Shoal Cycle SP-2021-0350C

September 7, 2022

Heritage Tree Variance Request

Site Constraints:

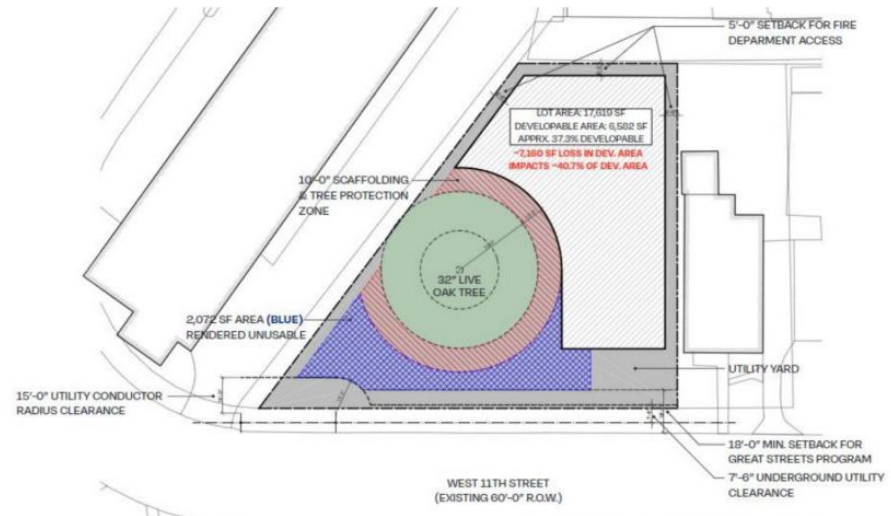
- The property is located in a portion of Downtown Austin that is ineligible for participation in the Downtown Density Bonus Program
- Restrictive Covenant requires 18'-0" setback along West 11th Street to align with Great Street Standards
- 5'-0" setback required along the northern, eastern and western property lines for fire department access
- The 32" Live Oak is centrally located on the property which divides the property and renders the southwestern portion (hatched in blue) unbuildable

Site Constraints- buildable floorplates

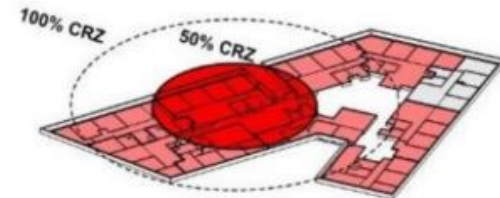
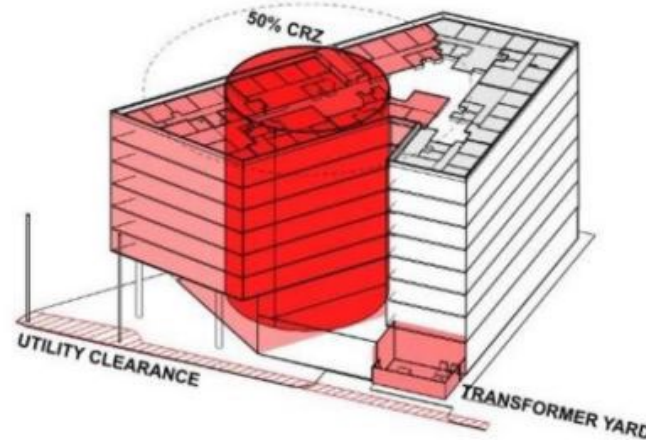
The root zone of the 32" Heritage Live Oak occupies 28.9% of site

- Current location results in a reduction of over 50% of the gross square feet of buildable area
- Preservation of the Half critical root zone would result in a loss of 28 units (or 42%) of the proposed 67 units
- Preservation of the Full critical root zone would result in a loss of 60 units (or 91%) of the proposed 67 units

Sonic tomography report

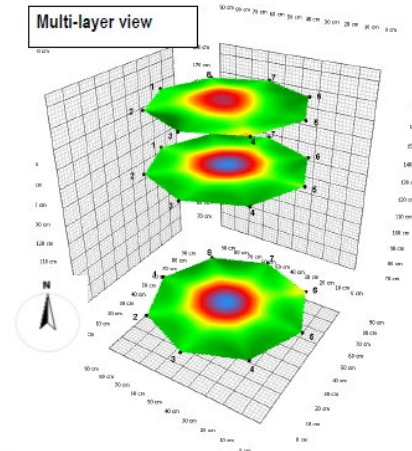
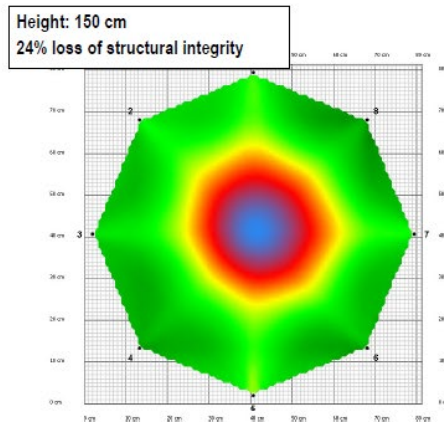
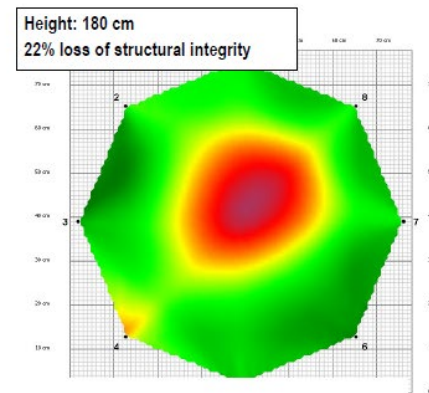
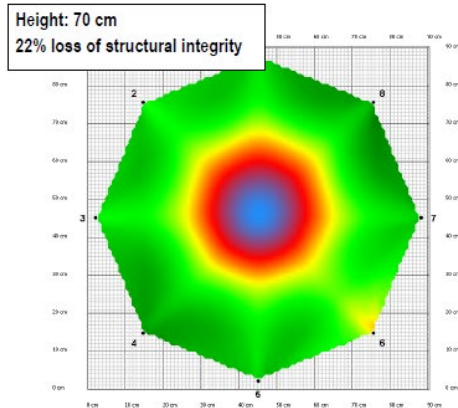
- Trunk leans over the parking lot. Sonic tomography was conducted of the trunk which indicated moderate decay present at three different vertical planes with the tree – estimates 22-24% loss in structural integrity of the tree. Large decay pockets on upper side of two scaffolding limbs observed.
